SUBJECT: AMENDMENT NO. 53 TO FACILITY OPERATING LICENSE NO. NPF-43:
(TAC NO. 69074)

The amendment revises the Technical Specifications to allow extended operation of Fermi-2 at reduced power with a single recirculation loop in operation.

AMENDMENT TO FACILITY OPERATING LICENSE

ATTACHMENT TO LICENSE AMENDMENT NO. 53

FIGURE 3.4.1.4-1

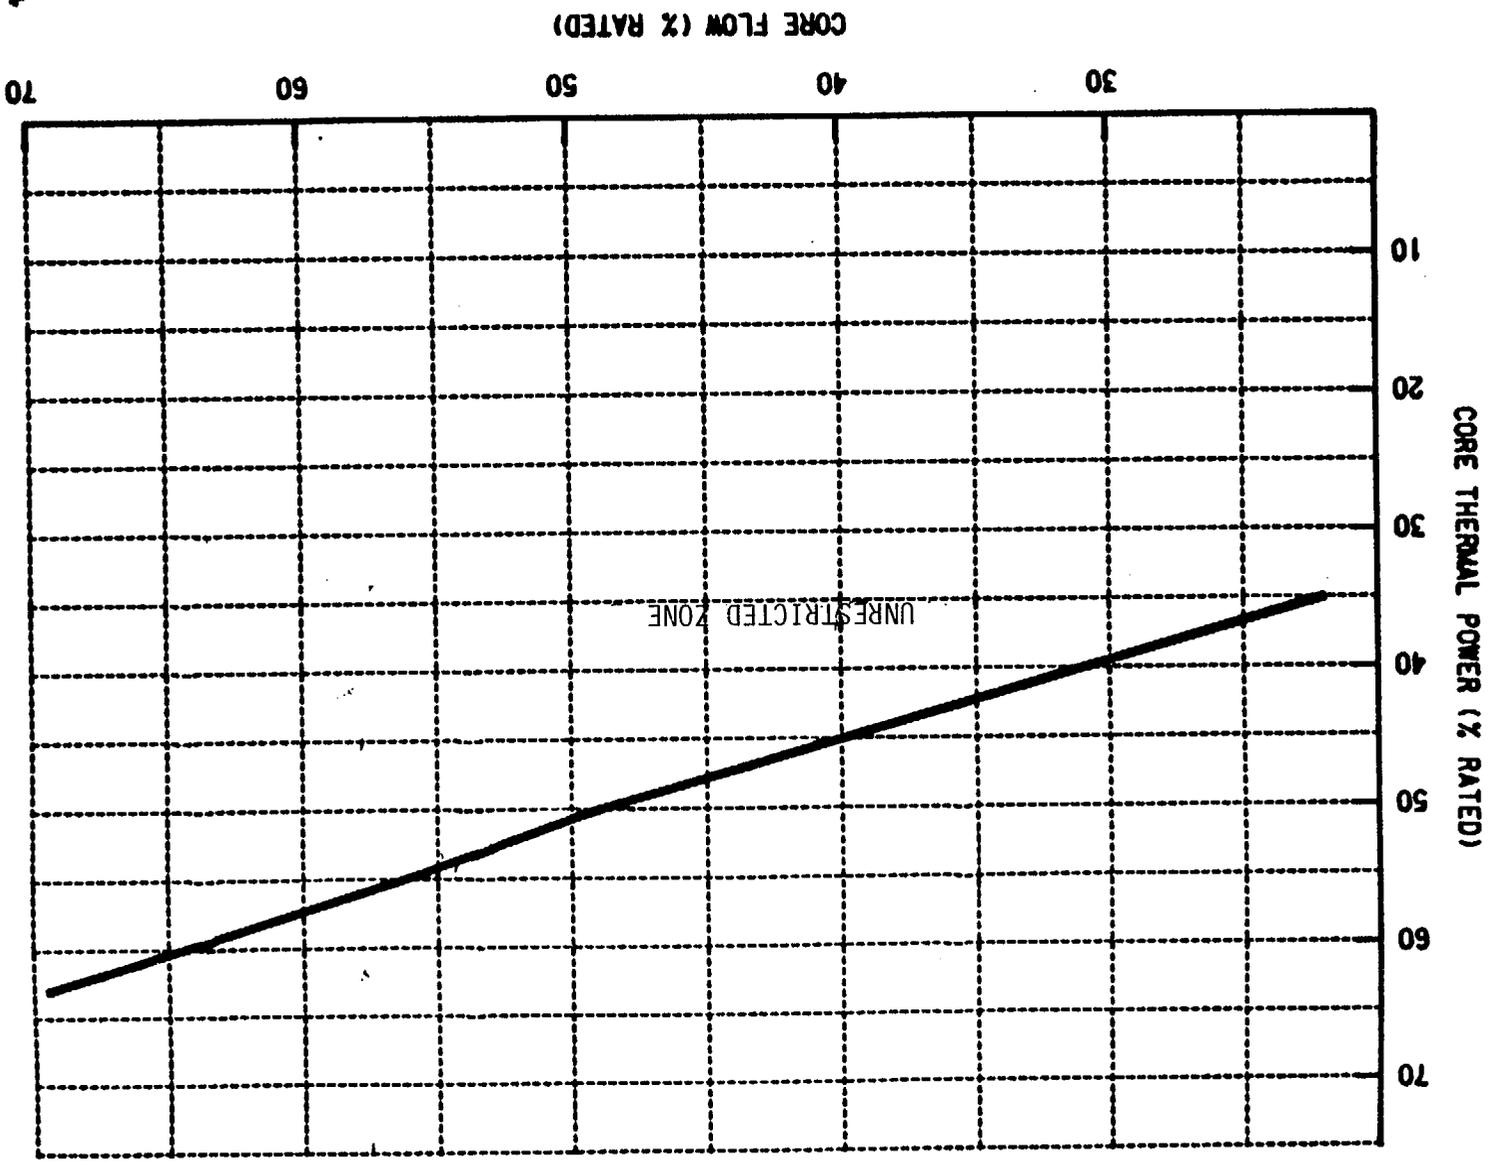
3.4.1.4 An idle recirculation loop shall not be started unless THERMAL POWER is within the unrestricted zone of Figure 3.4.1.4-1 and the temperature differential between the reactor pressure vessel steam space coolant and the bottom head drain line coolant is less than or equal to 145°F, and:

- a. When both loops have been idle, unless the temperature differential between the reactor coolant within the idle loop to be started up and the coolant in the reactor pressure vessel is less than or equal to 50°F, or
- b. When only one loop has been idle, unless the temperature differential between the reactor coolant within the idle and operating recirculation loops is less than or equal to 50°F and the operating loop flow rate is less than or equal to 50% of rated loop flow.

Specification 3.4.1.4. - The proposed change includes an additional restriction for idle loop start-up which is based upon thermal hydraulic instability concerns. During an idle loop start-up, there is a potential for thermal hydraulic instability if thermal power is not restricted to below the 80% rod line shown in the proposed Figure 3.4.1.4-1. Accordingly, the LCO, action and surveillance requirements have been modified to prohibit idle loop start-up in the region of concern. The proposed change is acceptable.

FIGURE 3.4.10 -1

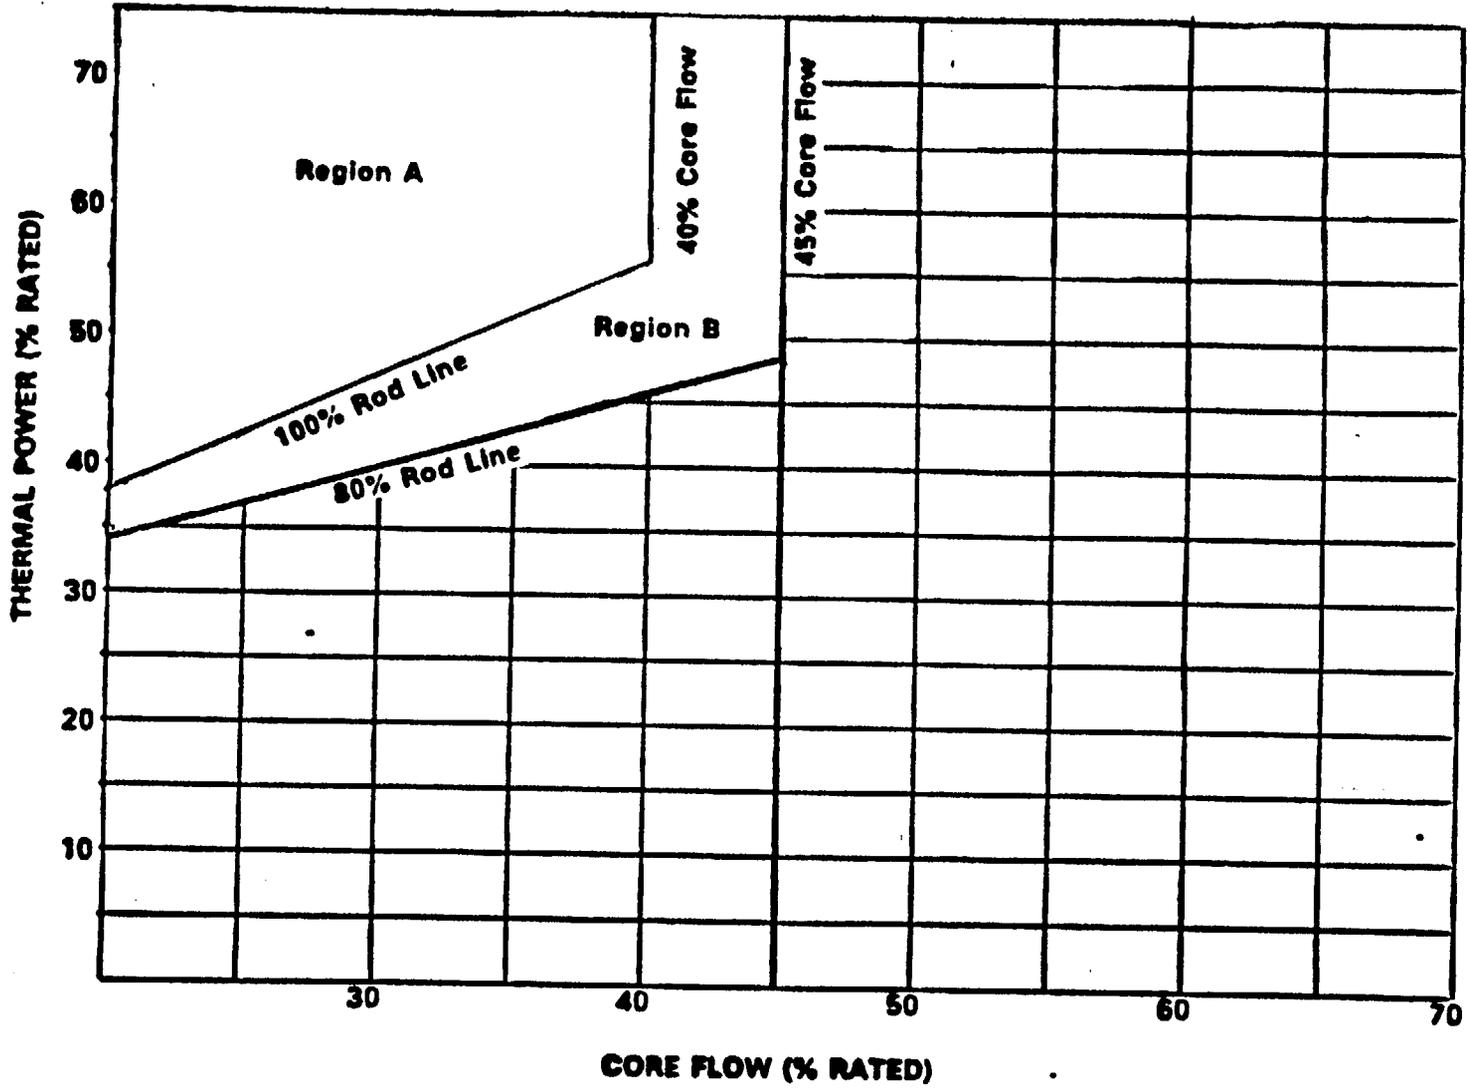
3.4.10 The Reactor core shall not be operated in Region A or Region B of Figure 3.4.10-1.

- a. With the Reactor operating in Region A of Figure 3.4.10-1, immediately place the Reactor Mode Switch in the SHUTDOWN position.
- b. With the Reactor operating in Region B of Figure 3.4.10-1, immediately initiate action to exit Region B by inserting control rods.
- c. If, while exiting Region B, core thermal hydraulic instability occurs as evidence by APRM readings oscillating by greater than or equal to 10% of RATED THERMAL POWER peak to peak or LPRM readings oscillating greater than or equal to 30 watts/cm² peak to peak, immediately place the Reactor Mode Switch in the SHUTDOWN position.

4.4.10.2 With THERMAL POWER greater than 30% of RATED THERMAL POWER and Core Flow less than 50% of Rated Core Flow, verify that the reactor core is not operating in Region A or Region B of Figure 3.4.10-1 at least once every 4 hours.

Region A and B of Figure 3.4.10-1 represent the least stable conditions of the plant (high power/low flow). Region A and B are usually entered as the result of a plant transient (for example, recirculation pump trips) and therefore are generally not considered part of the normal operating domain. Since all stability events (including test experience) have occurred in either Region A or B, these regions are avoided to minimize the possibility of encountering oscillations and potentially challenging the SLMCPR. Therefore, intentional operation in Regions A or B is not allowed. It is recognized that during certain abnormal conditions within the plant, it may become necessary to enter Region A or B for the purpose of protecting equipment which, were it to fail, could impact plant safety or for purpose of protecting a safety or fuel operating limit. In these cases, the appropriate actions for the region entered would be performed as required.

The new stability requirements are independent of the number of recirculation loops operating. The new Fermi-2 regions are displayed in the Figure 3.4.10-1. Immediate scram is required if region A is entered. The IRSA regions B and C are combined into a single Region B. The IRSA operating restrictions of region B were conservatively applied throughout Fermi-2 Region B. In Region B, control rods insertion is required immediately. The proposed regions provide a conservative representation of the Supplement 1 request and are acceptable.
